Access Compliance Report

Public Rights-of-Way

(Curb Ramps)

Intersection ID: 10253	Main Street: KILDARE_DR	Cross Street: RUTH_DR	Location: NE
ADA ID: CC617ABA5B3C	Ramp Type: BlendTrans1	Initial Pass/Fail: Fail	Overall Compliance: No
Severity Score: 1.25			
Codes/Mitigation Info/Possible Solution		Field Measurements/Component Compliance

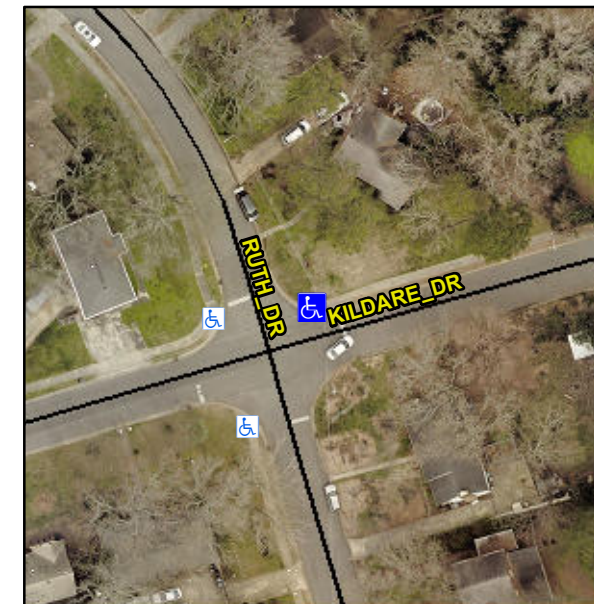
Not Found, R304.5.3

Compliance	Description	Data	Compliance	Description	Data
N/A	Ramp Length (in)	115.5	Yes	BlendTrans Slope (%)	1.7
Yes	Ramp Width (in)	60.0	No	BlendTrans XSlope (%)	2.6
N/A	Flare Type LT	N/A	N/A	Flare Type RT	N/A
N/A	Flare Slope LT (%)	N/A	N/A	Flare Slope RT (%)	N/A
N/A	Flare Traversable LT?	N/A	N/A	Flare Traversable RT?	N/A
N/A	Landing Length (in)	N/A	N/A	DWS Provided?	N/A
N/A	Landing Width (in)	N/A	N/A	DWS Contrast?	N/A
N/A	Landing Slope (%)	N/A	N/A	DWS Length (in)	N/A
N/A	Landing X Slope (%)	N/A	N/A	DWS Full Width?	N/A
N/A	Landing Curb? (Y/N)	N/A	N/A	DWS Offset (in)	N/A
N/A	Shared Landing?	N/A			
N/A	Gutter Ponding?	N/A	N/A	Gutter Slope (%)	N/A
N/A	Gutter Lip Ht (in)	N/A	N/A	Gutter X Slope (%)	N/A
N/A	Painted X Walk1?	No	N/A	Painted X Walk2?	N/A
	X Walk 1 Direction	To W		X Walk 2 Direction	N/A
	X Walk 1 Width (in)	N/A		X Walk 2 Width (in)	N/A
	X Walk 1 Slope (%)	2.0		X Walk 2 Slope (%)	N/A
	X Walk 1 X Slope (%)	0.4		X Walk 2 X Slope (%)	N/A

N/A	Ramp inside XWalk1?	N/A	N/A	Ramp inside XWalk2?	N/A
	Road Slope (%)	0.4		Clear Space?	N/A
	Road X Slope (%)	2.0	N/A	Clear Space to XWalk (in)	N/A
N/A	Any Obstructions?	N/A	N/A	Storm Grate/Utility Hazard?	N/A
	Obstruction Type			Storm Grate/Utility Type	
		N/A			N/A
			Yes	Surface Condition? (G/P)	Good
			No	Curb Slope (%)	17.0

Remove & Replace Curb Ramp With Two New Directional Ramps or Equivalent.
